Service Bulletin

Bulletin No: 23 002 04 (025)

Topic: Ball End Working Loose on Gearshift Lever.
F 650 CS

Picture 1

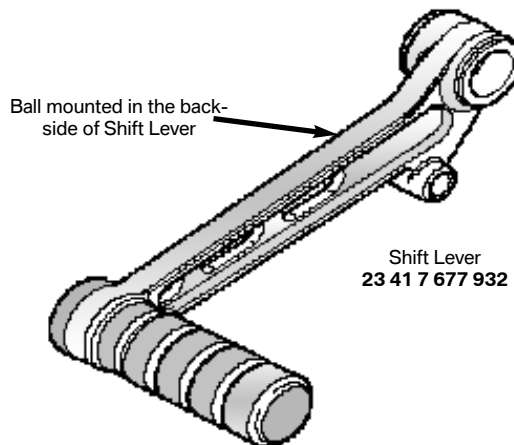
Subject: The ball end mounted on the inside of the gearshift lever can work loose. In the worst case this may cause the gearbox to shift with difficulty, or not at all.

- Service:**
- 1: Check the security of the ball end on the shift lever.
 - 2: If the threaded ball end is found to have worked loose on the shift lever, remove the entire shift lever and install the modified shift lever with reworked ball end.

Part Number: **23 41 7 677 932**
Description: New Shift Lever
Qty: 1
